JOHN A. DRON
Box 25A, Gridley Rd.
OJAI, CALIFORNIA

At long last I have finished the " as built" plans of the Meiners Oaks Reservoir, and I send you a copy. Will you look it over and return it with any comments, so I can change it before making the two final process tracings as required by the Department.

SUBJECT: Meiners Oaks Dam,
No. 768

Meiners Oaks Dam No. 768

Picture looking upstream through
spillway showing grill over exit
portal.

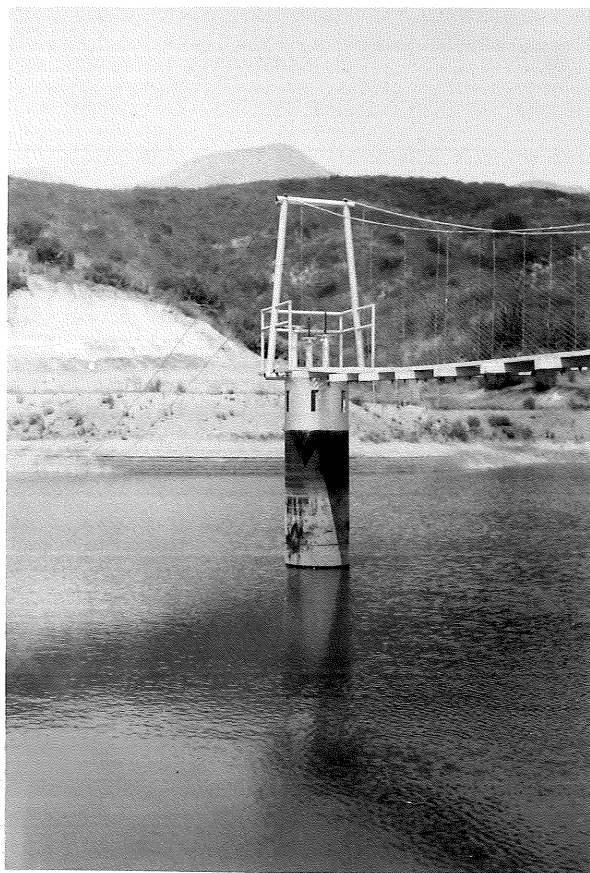
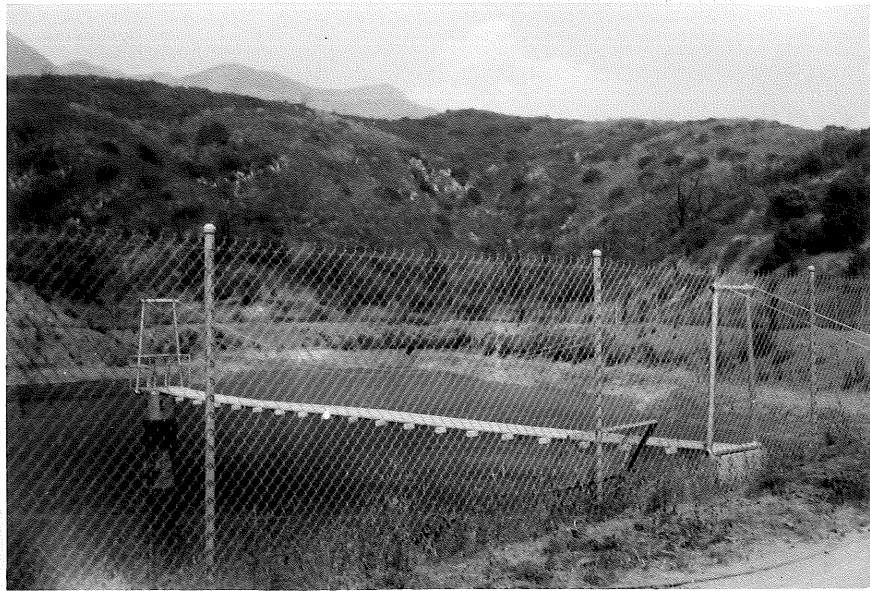
I mentioned that the completed drawings and cost statement had not been submitted yet and that this should be done in the near future. They will remind Mr. Dron about submitting the drawings, which he said on last December 24th would be completed in a few days. I explained about the completed cost statement to Mrs. Young and left her a copy of the rules and regulations. The only notification of completion has been a letter by Mr. Dron dated October 24, 1950 in which he requests a temporary permit to store water. Does this meet the requirements for notification of completion? Mr. Young said he had installed a grill in the spillway entrance to keep children out of the reservoir.

After this visit to the office, I made an unaccompanied inspection of the reservoir. The water surface was 8⁺ ft. below the spillway and there was no visible seepage. The grill Mr. Young mentioned was located on the downstream portal of the spillway. I believe it would be preferable on the upstream side since its present position would allow clogging without any way of clearing or racking during a high flow. However, with the fence around the reservoir, it is questionable if enough debris would enter the reservoir to clog this grill. A 3" x 12" board had been placed in the spillway. Shouldn't they request permission by application to do this and then for only certain months of the year? If this board is meant to serve only the purpose of keeping wave action from going over the spillway, does it change the requirements? Your comments concerning the flashboard and grill will be appreciated, then I can see them on my next trip up there and advise them of any necessary requirements in this regard.
